FINAL
Environmental Impact Report
Merced Gateway Master Plan
City of Merced, Merced County, California
State Clearinghouse Number 2015101048

Date: June 7, 2017

SECTION 2: RESPONSES TO WRITTEN COMMENTS

Exhibit 3.11-27 Mitigations Cumulative Plus Project with General Plan Streets Lane Configurations

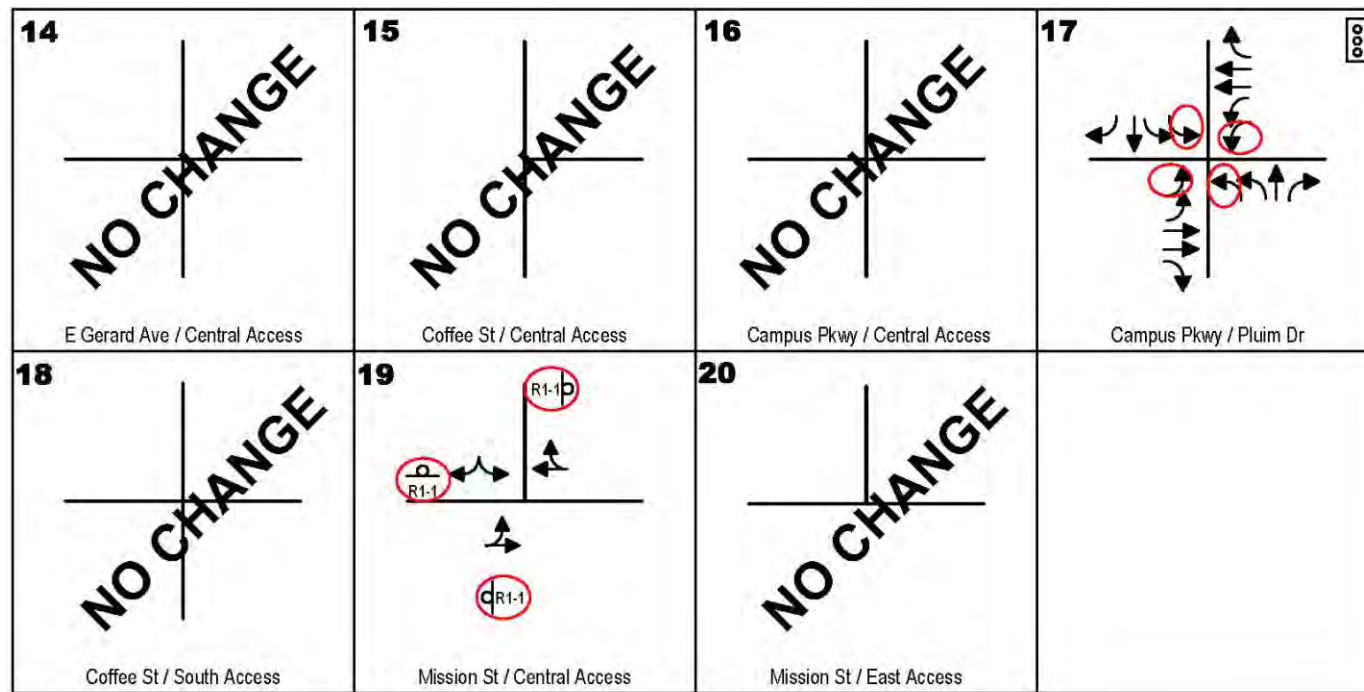
8. Under the "Access as Proposed" scenario, the Merced Gateway DEIR's TIS provides the traffic analysis and mitigations for "Existing Plus Project Conditions", "EPAP Plus Project Conditions", and "Cumulative Plus Project Conditions". However, under the General Plan Circulation scenario, the TIS ignores the "EPAP Plus Project Conditions". The DEIR's TIS needs to mitigate the project's significant impacts during the "EPAP Plus Project with General Plan Circulation Conditions".

Exhibits 3.11-11, 3.11-12, 3.11-13, 3.11-18, 3.11-19, 3.11-24, 3.11-25, 3.11-26, and 3.11-27, and Tables 3.11-16, 3.11-28, 3.11-37, 3.11-38, and 3.11-39 from the DEIR (corresponding to Figures 22, 23, 24, 26, 27, 28, and 29 and revised Tables 37, 41, and 43 from the Traffic Study in Appendix I of the DEIR) are also changed to reflect the revised mitigation measures and the correction to the Mitigated Cumulative Year 2035 condition for Mission Avenue/State Route 99 northbound and southbound ramps, from LOS “D” to “B” in the AM Peak Hour, and the Mission Avenue/State Route 99 southbound ramps from LOS “C” to “B” in the PM peak hour. The revised pages of the EIR follow.
